UNITED STATES DEPARTMENT OF THE INTERIOR BUREAU OF LAND MANAGEMENT SUNDRY NOTICES AND REPORTS ON WELLS

United States
Department of The Interior
Carlsbad, New Mexico
Re: Condor 7 Fed #3H
Sec 7-T18S-R27E
Eddy County, New Mexico
API # 30-015-36970

Devon Energy would like to make the following changes to the approved drilling design for the above referred well.

· RE: Change to APD Plan – Conditions of Approval

11" x 5,000 psi BOP Stack

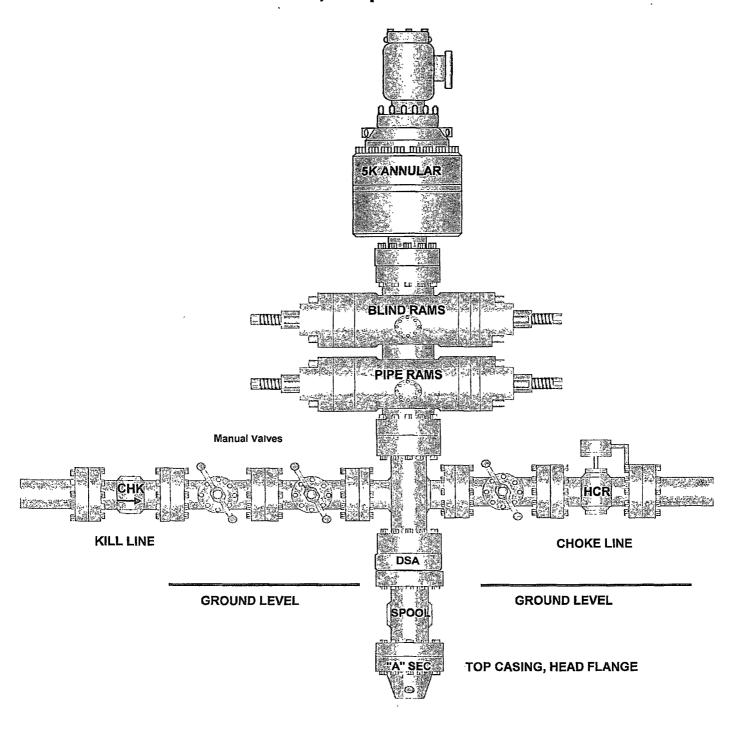
•					
will be tested as per BLM Onshore Oil and Gas Order No. 2 as a 3M system prior to drilling out the surface casing shoe. The BOP system used to drill the production hole will consist of an 11" 5M Double Ram and Annular preventer. The BOP system will					
be tested as per BLM Onshore C					
The pipe rams will be operated a					
logged in the daily driller's log. A					
addition to the rams and annular choke manifold rated at 5,000 ps		accessories include	е а кену сос	ck, floor safety valve,	cnoke lines, and
onoke marmola rated at 3,000 ps	(VVI-,				
.					
<u>Production Casing Change</u> from describing the production casing		hole isolation tool to	5 1/2" produ	uction casing (see atta	ached letter
describing the production casing	changes in detail) .	ATT 4 5754 AT			
SEE ATTACHED FOR					
CONDITIONS OF APPROVAL					
			·

- 1. All blowout preventer (BOP) and related equipment (BOPE) shall comply with well control requirements as described in Onshore Oil and Gas Order No. 2 and API RP 53 Sec. 17.
- 2. Minimum working pressure of the blowout preventer (BOP) and related equipment (BOPE) required for drilling below the surface casing shoe shall be 5000 (5M) psi. 5M system requires an HCR valve, remote kill line and annular to match. The remote kill line is to be installed prior to testing the system and tested to stack pressure

- 3. Minimum working pressure of the blowout preventer (BOP) and related equipment (BOPE) required for drilling below the surface casing shoe shall be **3000 (3M)** psi.

- 4. Minimum working pressure of the blowout preventer (BOP) and related equipment (BOPE) required for drilling below the 7 intermediate casing shoe shall be 5000 (5M) psi. 5M system requires an HCR valve, remote kill line and annular to match. The remote kill line is to be installed prior to testing the system and tested to stack pressure.
